ADDENDUM #1

FOR
EV CHARGER UPGRADES AT VARIOUS SITES
FOR
NEWMAN-CROWS LANDING UNIFIED SCHOOL DISTRICT
Bid Time and Date: September 23, 2026 at 1:00 p.m.

EV CHARGER UPGRADES

NEWMAN - CROWS LANDING USD

AS.1

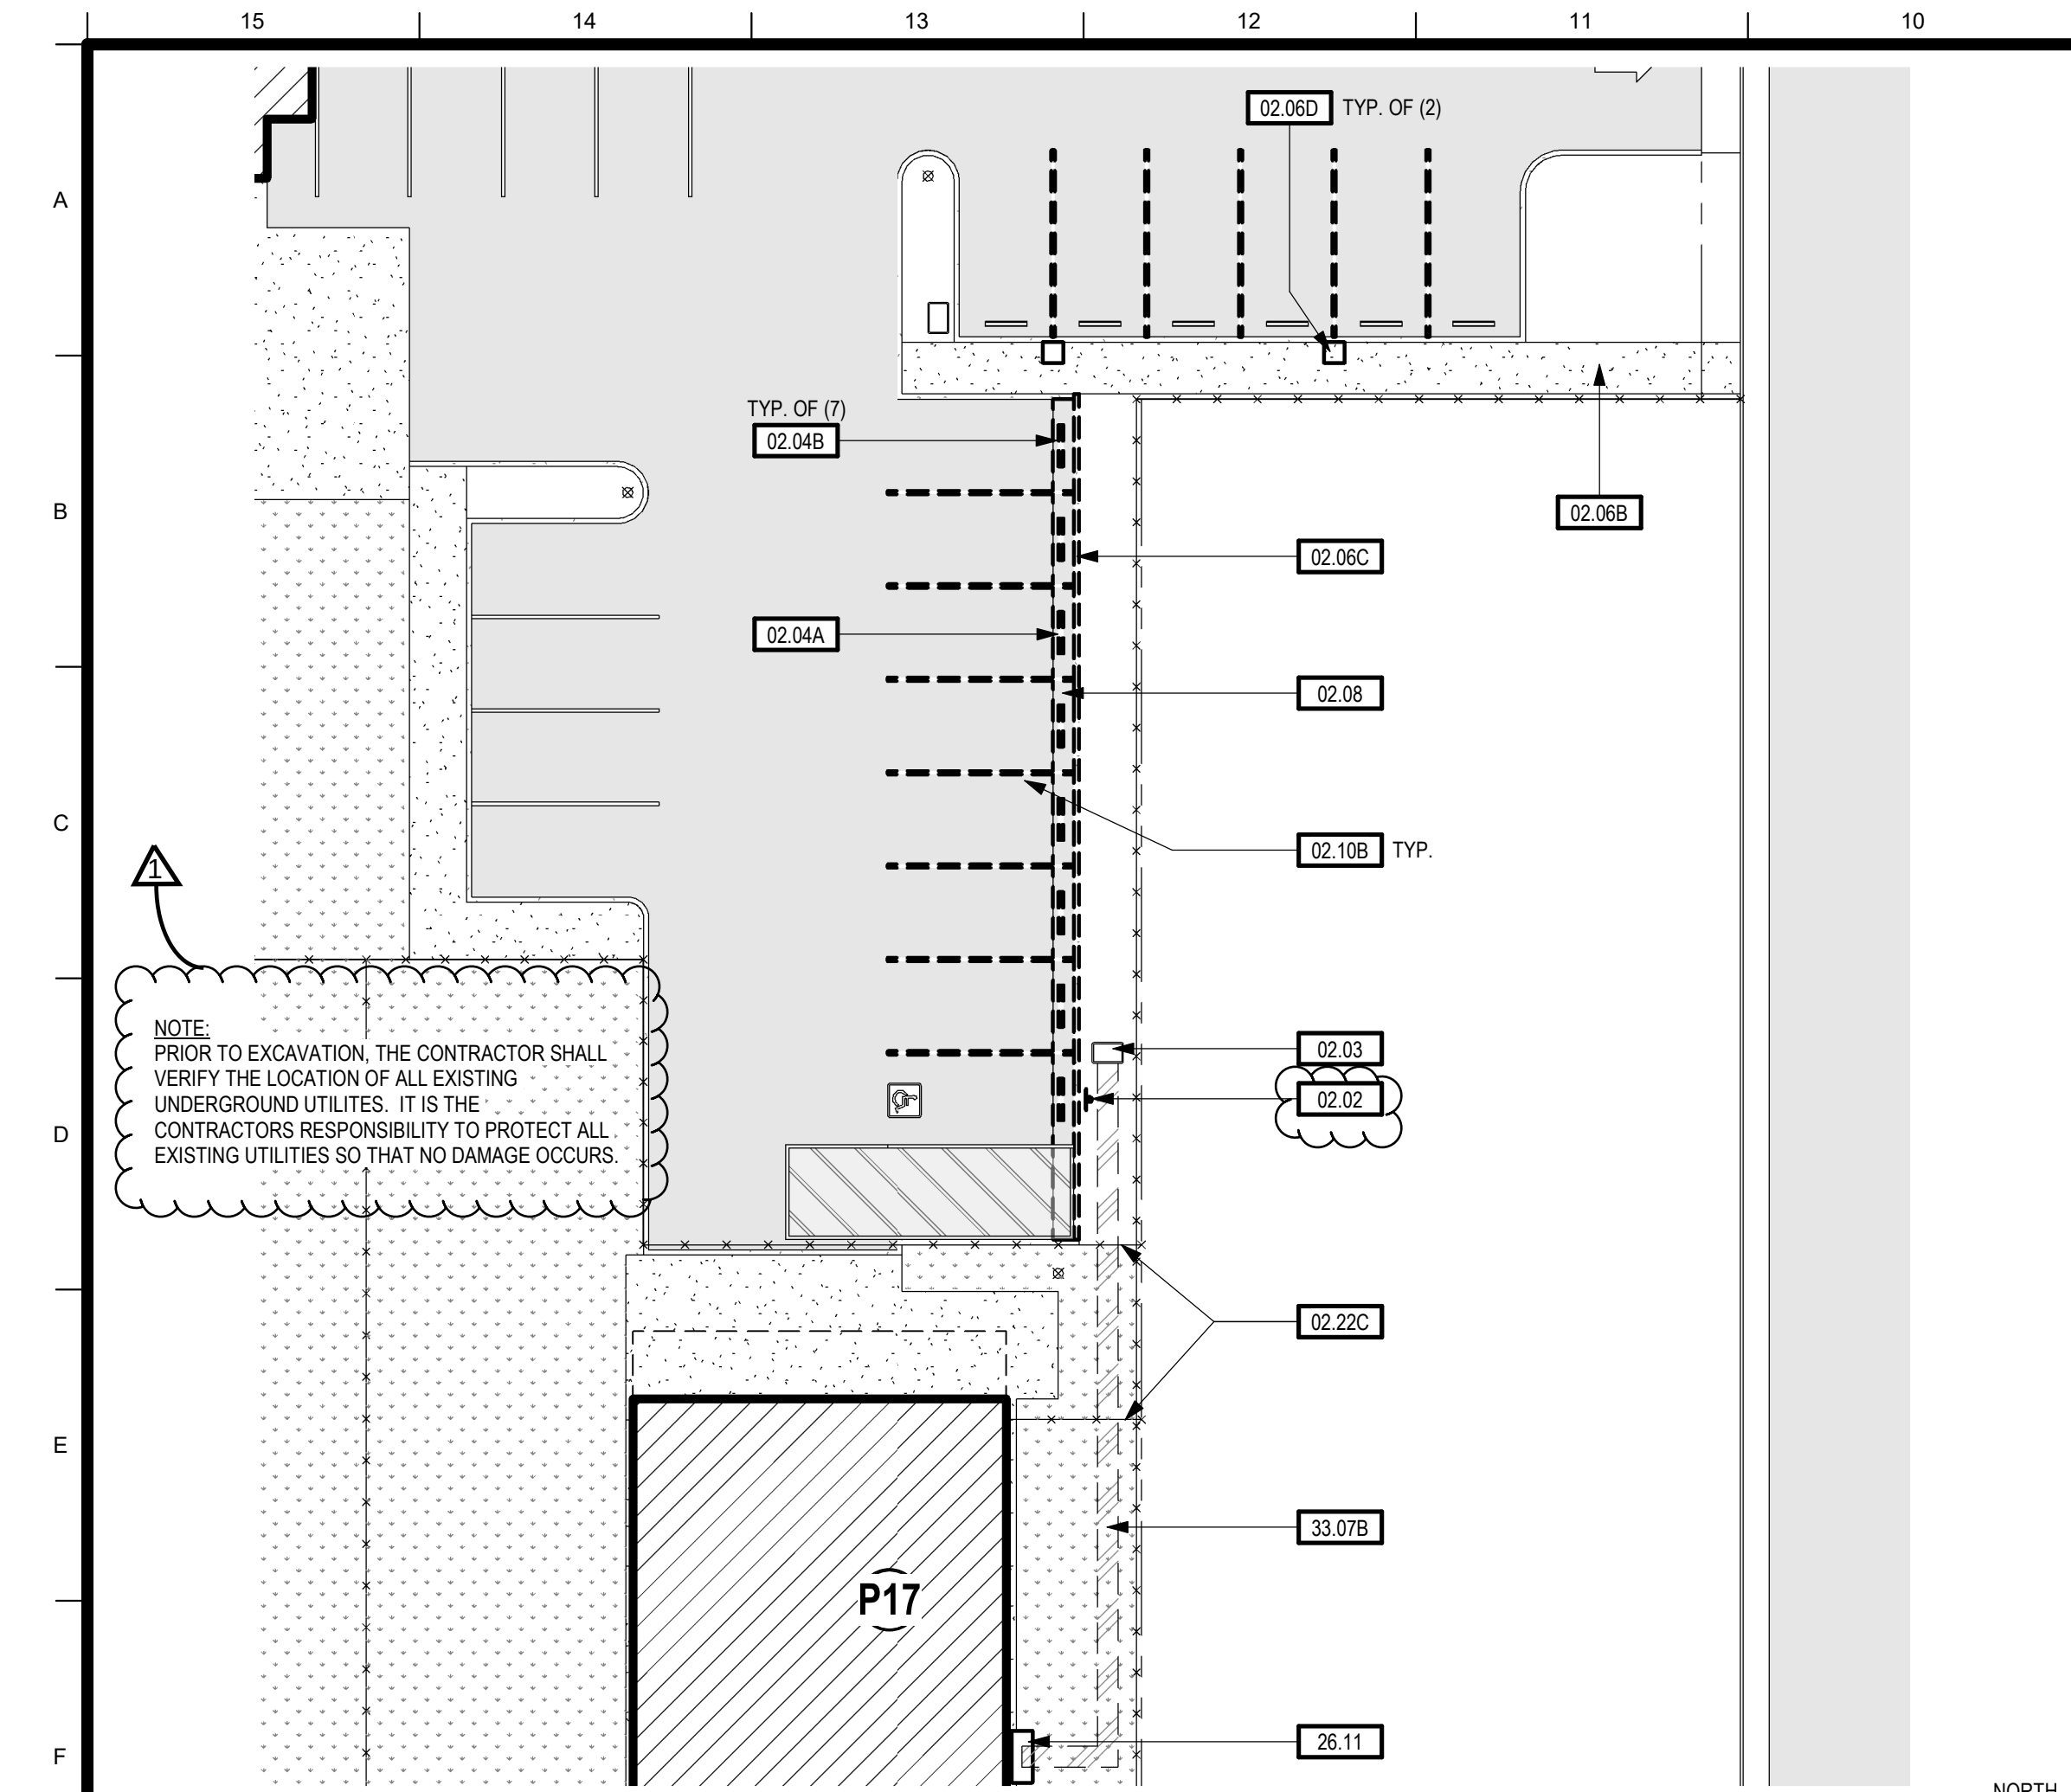
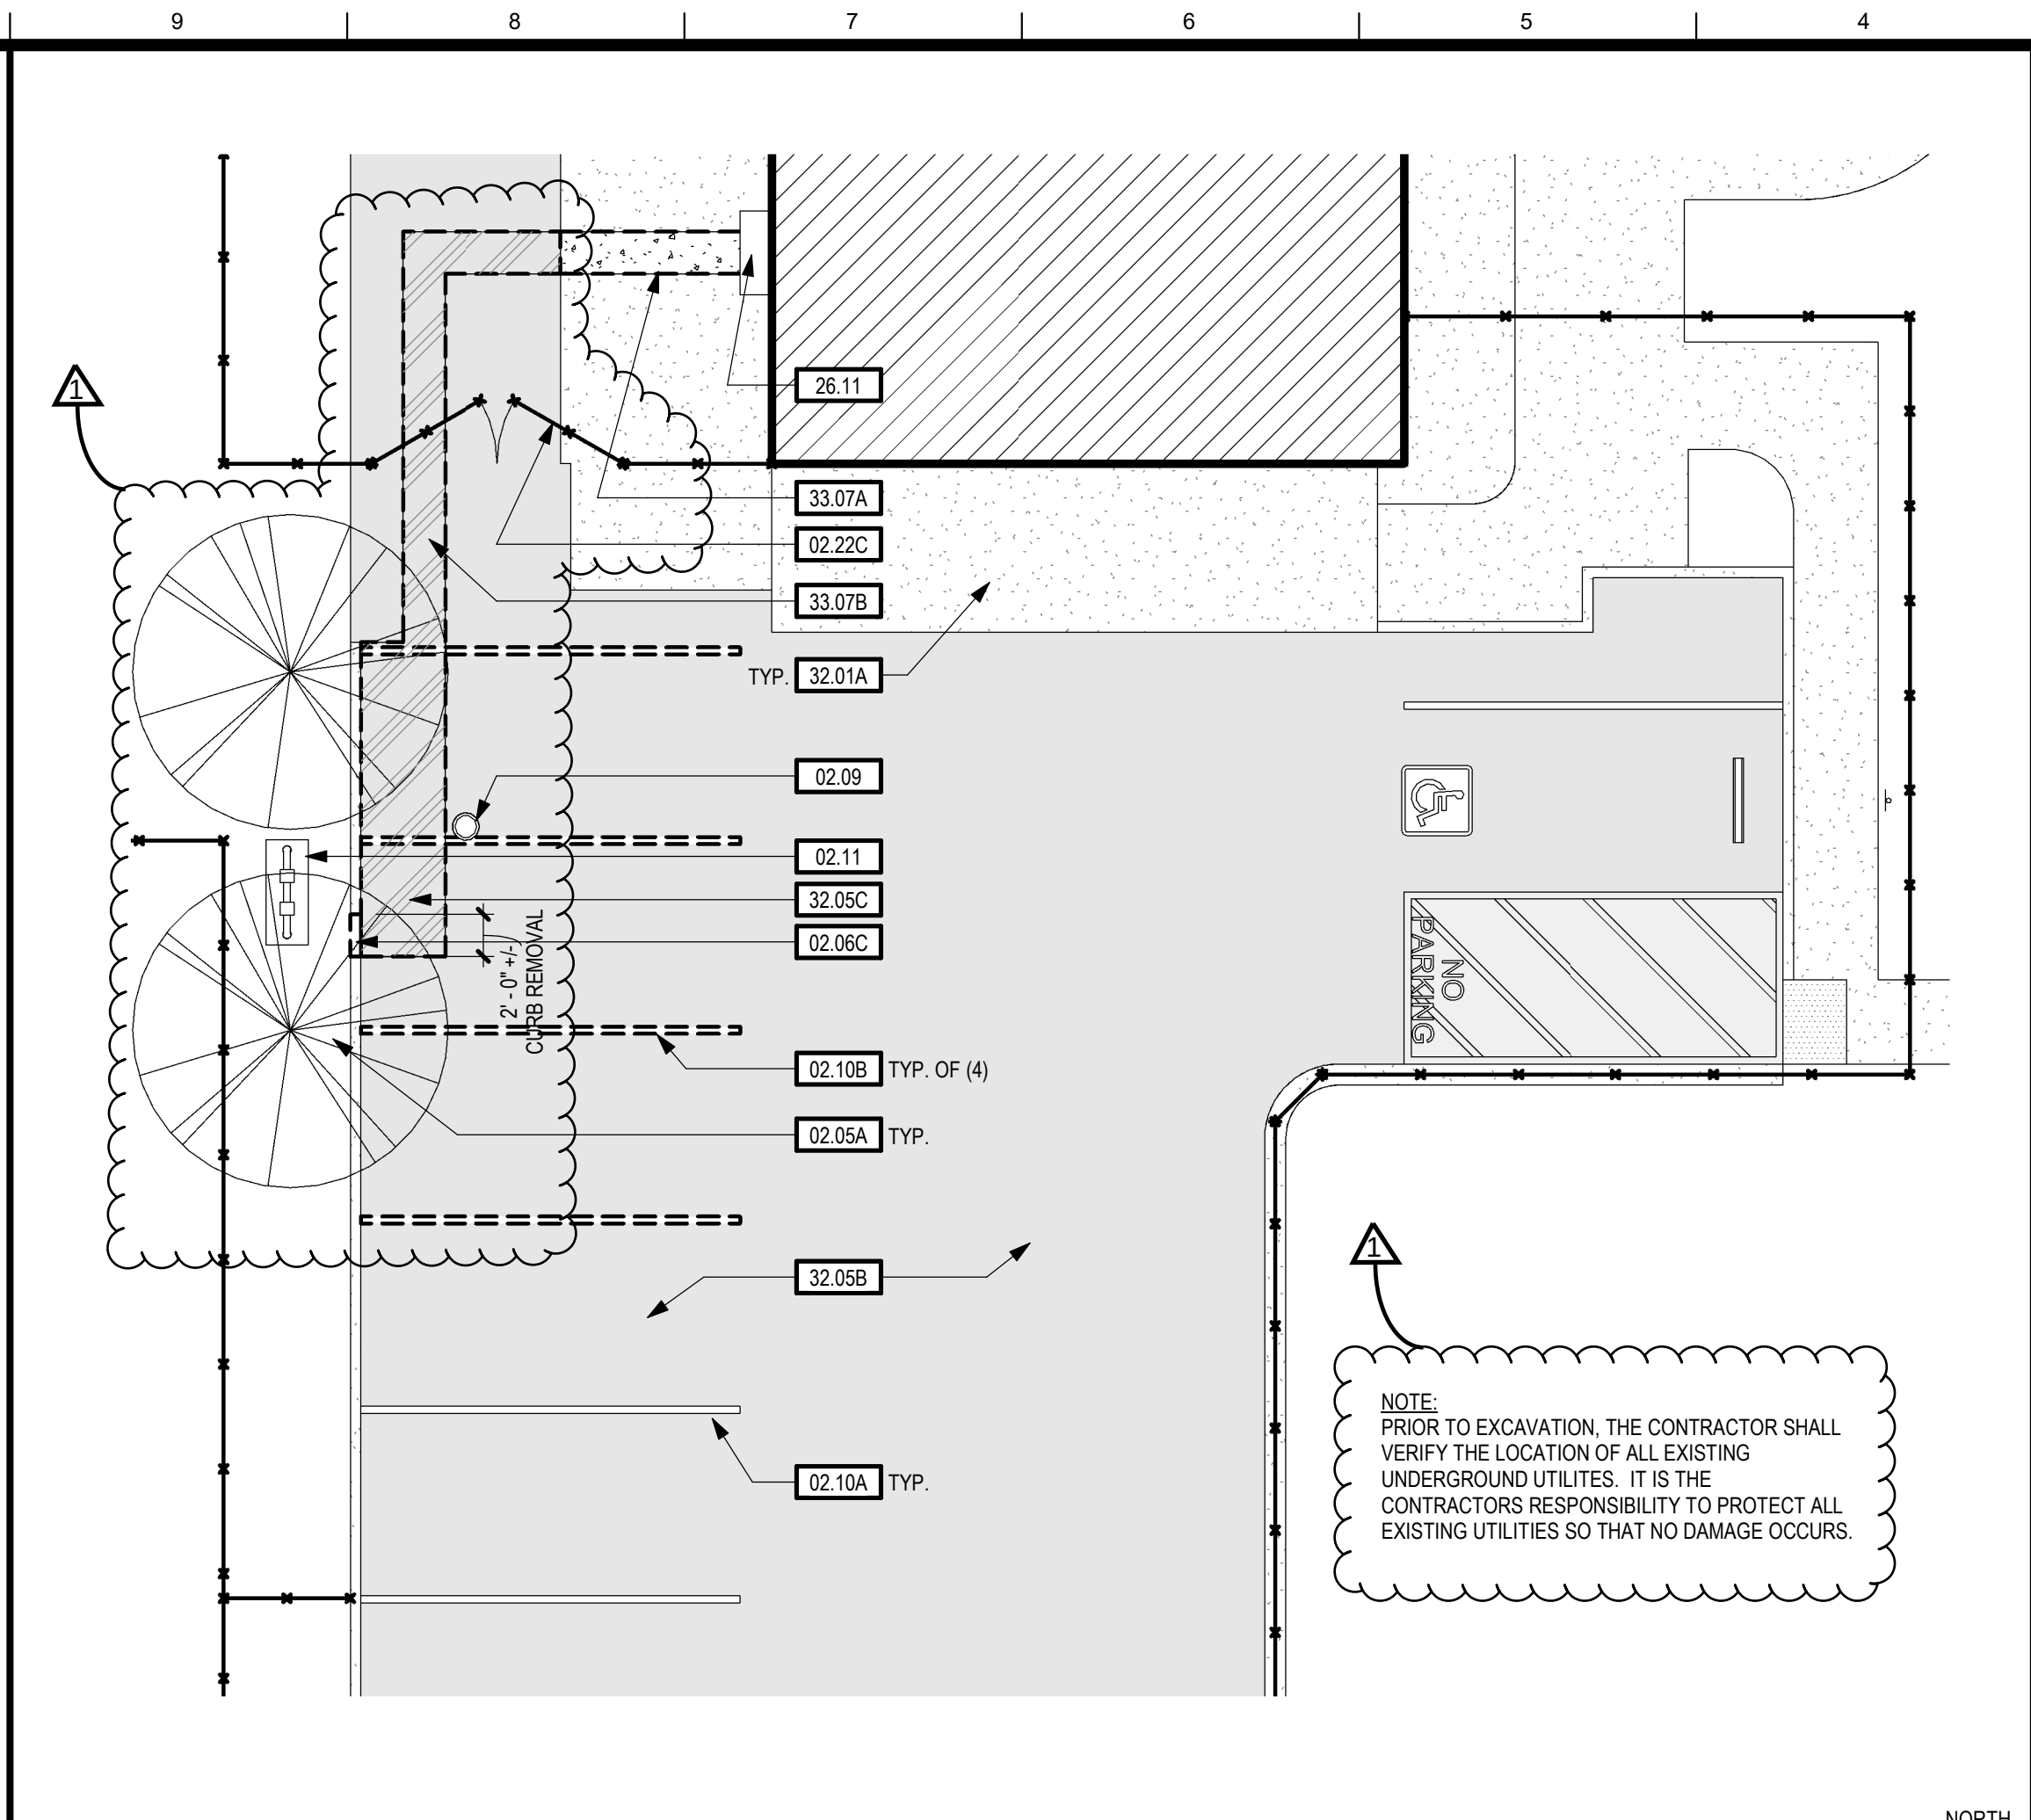
Item 001.:Reference Sheets AS.1 & ES.1 – Electrical Trench Location:
The trench location was moved to avoid trees and existing utilities.

Item 002.:Reference Sheets AS.1 & AS.2 – Accessible Sign Detail:
Detail 14/AS.2 revised for the sign at Hunt Elementary.

Item 003.:Reference Sheet AS.2 – Asphalt Trench Repair Detail:
Detail 15/AS.2 added for the asphalt repair at Bonita Elementary.
